**National Committee on  
Seismic Design Parameters (NCSDP)  
for River Valley Projects**

**MINUTES  
OF  
31<sup>st</sup> MEETING  
(23<sup>rd</sup> June, 2016)**

**MINUTES OF THE 31<sup>ST</sup> MEETING OF  
NATIONAL COMMITTEE ON SEISMIC DESIGN PARAMETERS FOR RIVER VALLEY PROJECTS  
HELD ON 23<sup>RD</sup> JUNE, 2016 AT CWC, NEW DELHI**

#### **31.3.4 Kwar Hydro Electric Project, Jammu & Kashmir**

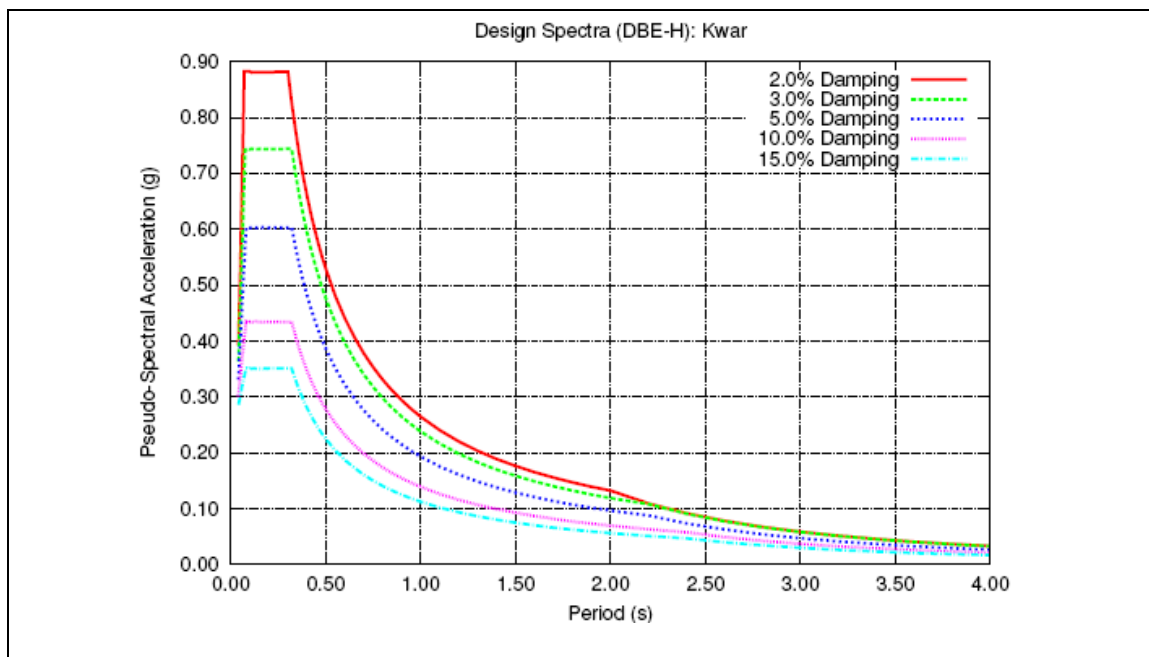
1. The array used for acquiring the MEQ data from the three projects is not well designed. All the stations are on southern side of Pakal Dul with only one station on the dam site itself. Similarly, the stations are falling on the SW of the projects Kiru and Kwar. The array may not cover spatially the MEQs occurring in the vicinity of these dam sites from the point of view of estimating the depths.

2. The objective of the study as given in the report are not falling in line with the objectives with which these studies are supposed to be carried out.

3. The seismicity as reported by IMD is shown to have magnitude ranges 1-2, 2-3, 3-4, 4-5 and 5-6, however, the Table is not representing the statement made in the text. There are no earthquakes less than 3 (which are called as microearthquakes) reported in the table 2 of the report which also is not required in such reports.

4. Please attach the Sushil, (2016) unpublished report as annexure to this report.
5. No justification has been given as to why only 13 earthquakes are located as given in Table 6, 14 are located as given in Table 7 while 178 events are reported to be recorded by the array.

6. No microearthquakes have been reported in this report in such a seismically active region.
7. The report is badly written without understanding of objectives with which these microearthquake networks are to be deployed around HE projects for six months.

8. Fig 31, 32 and 33 are not relevant and serves no purpose.
9. The discussion and conclusions section says that total 13 earthquakes have been recorded during the six months period in the 50 km radius from the centre of Kiru, Kwar and Pakal dul project sites. These are not microearthquakes.

1. It is not given in the report that the computation of the magnitude and location of the events have been done using the software SEISAN, it could be elaborated a little more by giving the formulae used.

2. Since the study is on microearthquakes the events with magnitude greater than or equal to 1.0 need to be mentioned in Table 9.

**After brief deliberation, the Committee accorded approval to the study report of Kwar H E Project, Jammu & Kashmir incorporating the revised seismic design parameters arrived as per Committee's decisions under item 31.1 and as summarized below. The Committee also noted that its approval is conditional subject to the submission of revised/updated MEQ studies report incorporating the compliance to the observations of the Committee by the project authorities by June, 2017.**
